SHEET 3 OF

CITY OF HARTFORD, CONNECTICUT DEPARTMENT OF ENGINEERING		
CEMETERY BROOK CONDUIT G.H.F.C. Serial No. 000519		
SUBMITTED	RECOMMENDED	APPROVED
DIVISION ENGINEER	ASST. CITY ENG.	CITY ENGINEER
DESIGN	DRAWN	DAYBOOK NO. 09430
TRACED	CHECK	DATE

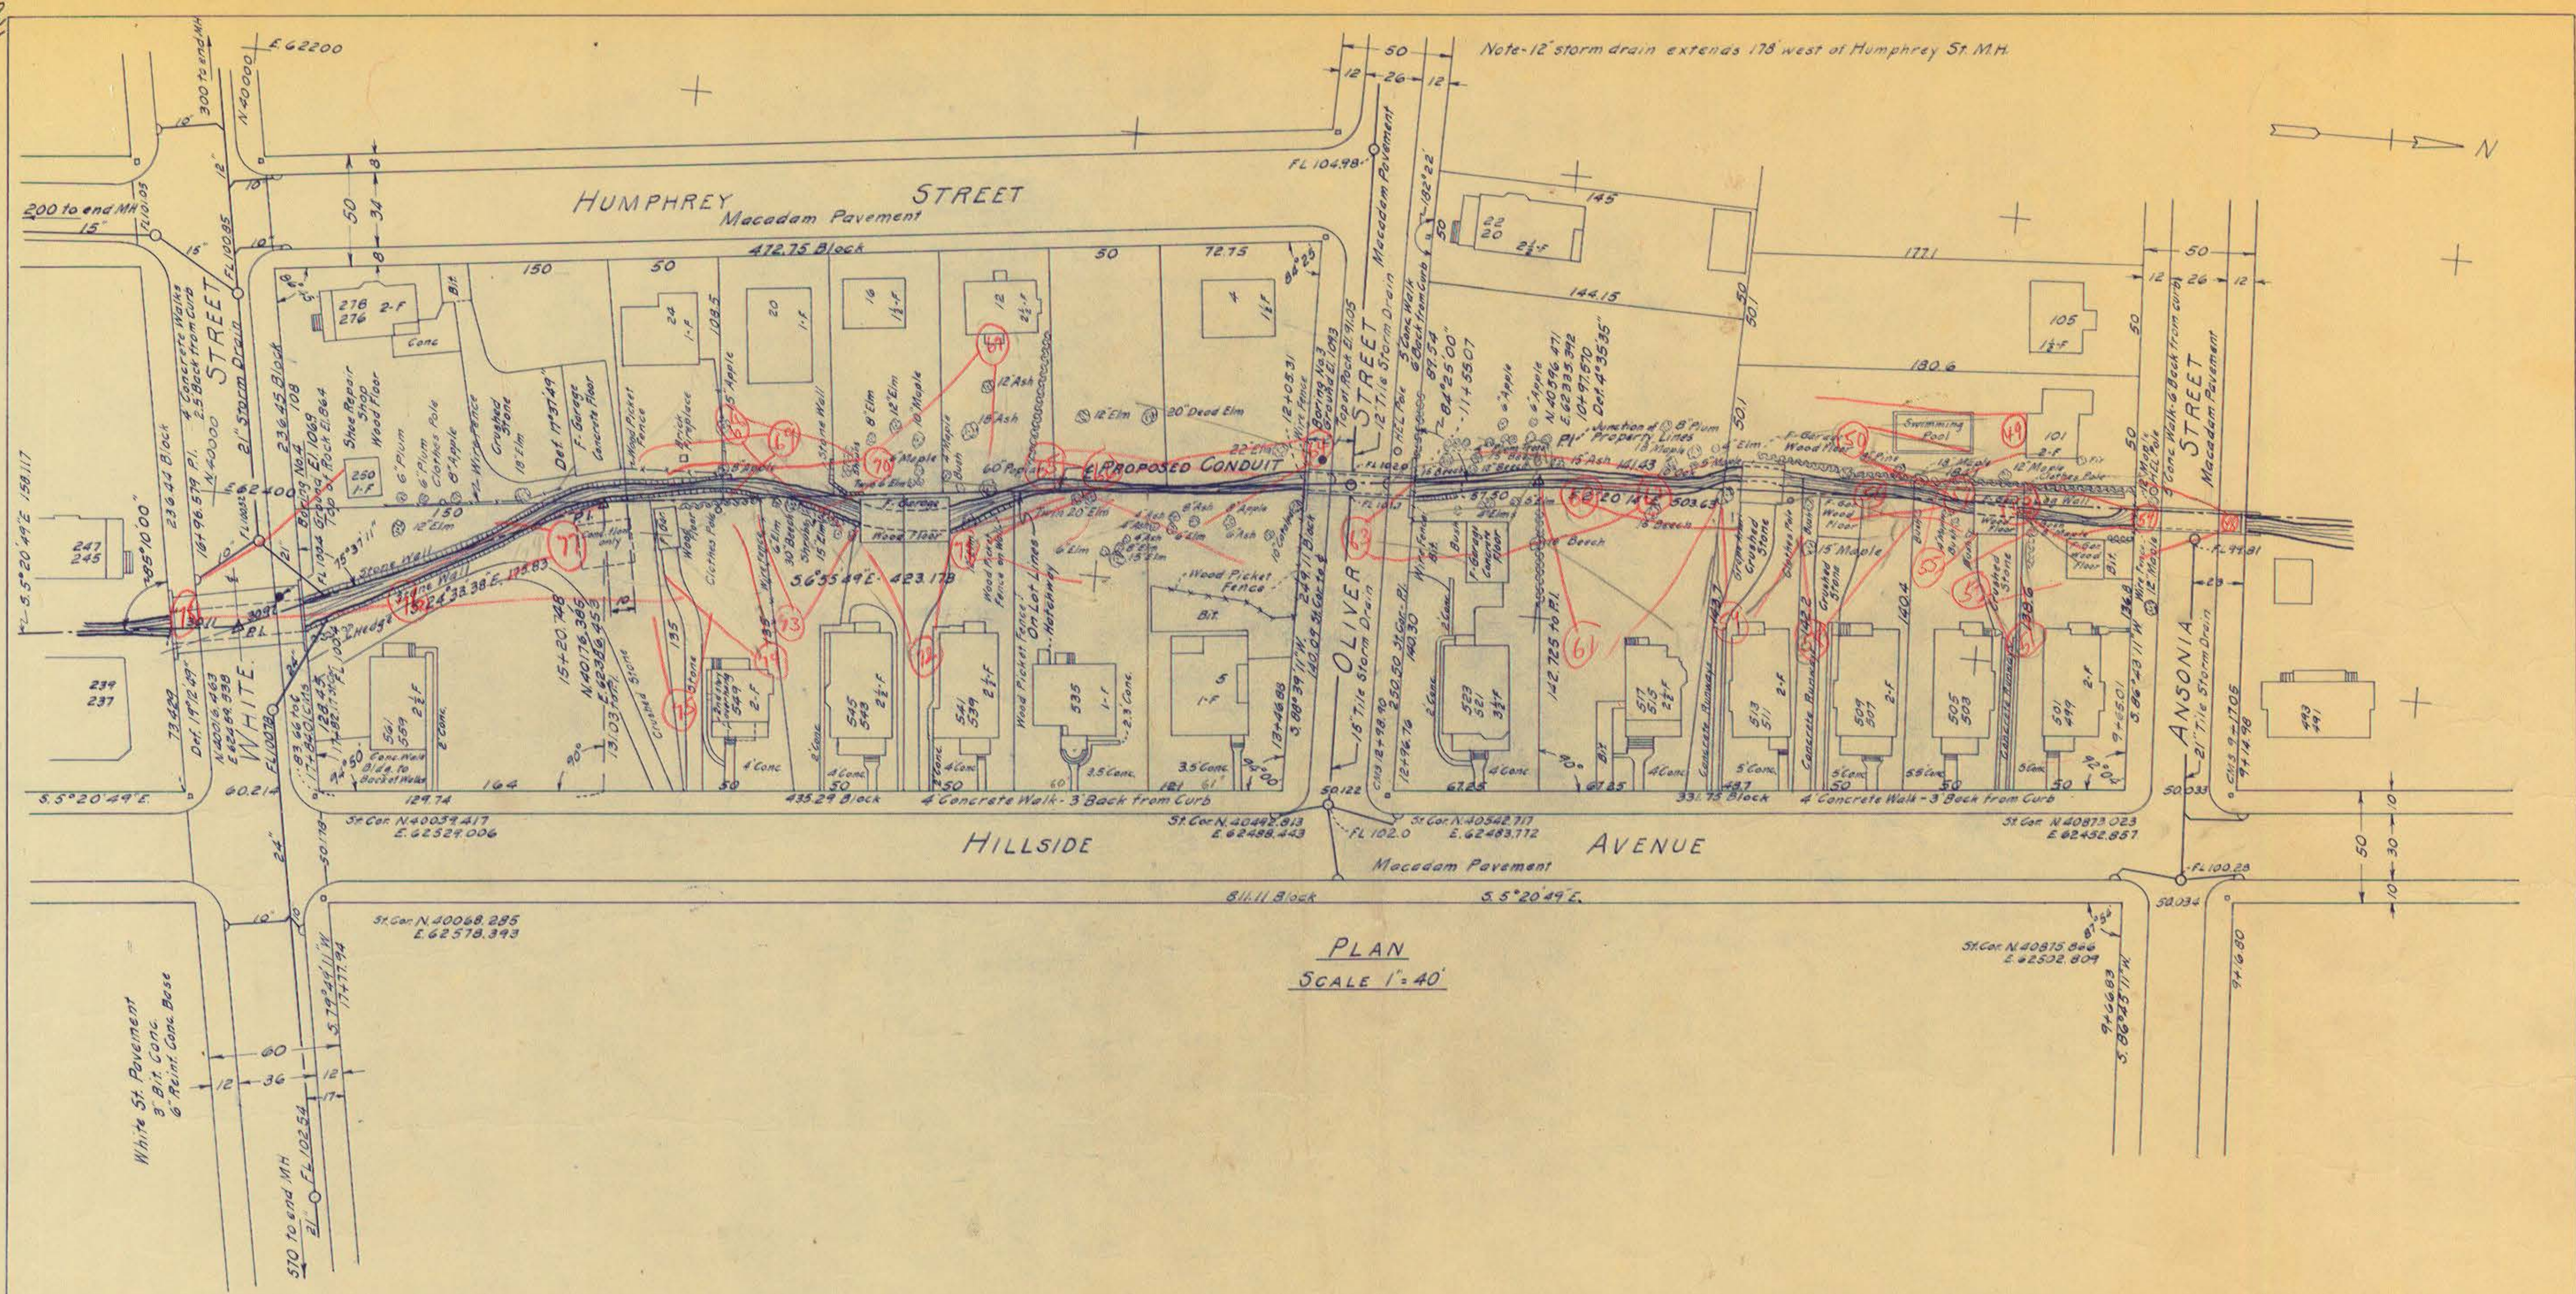
Revision of October, 1956 - Entrance walks and driveways plotted
